REMARK

Application No. 10/716,941
Reply to Office Action dated October 14, 2004

Fig. 5

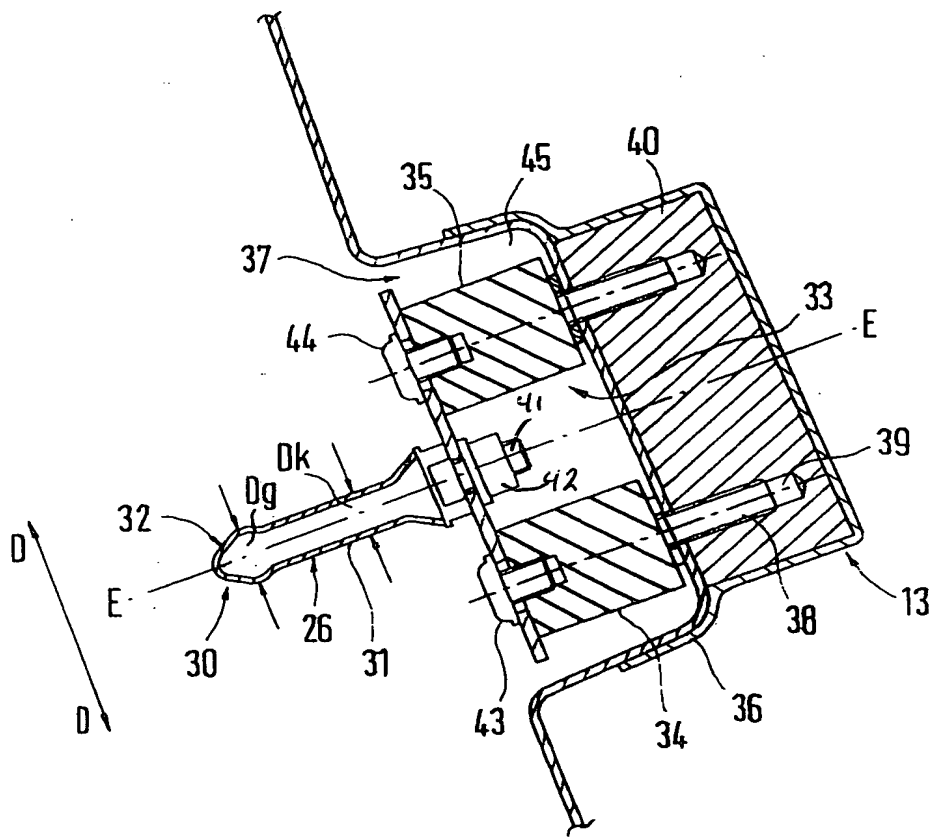
Please amend Figures 4-6 and 11 by replacing the drawing sheets including these figures with the replacement drawing sheets appended to this Reply. Also appended to this Reply are copies of the original drawing sheets showing, in red, the changes made to Figures 4-6 and 11.
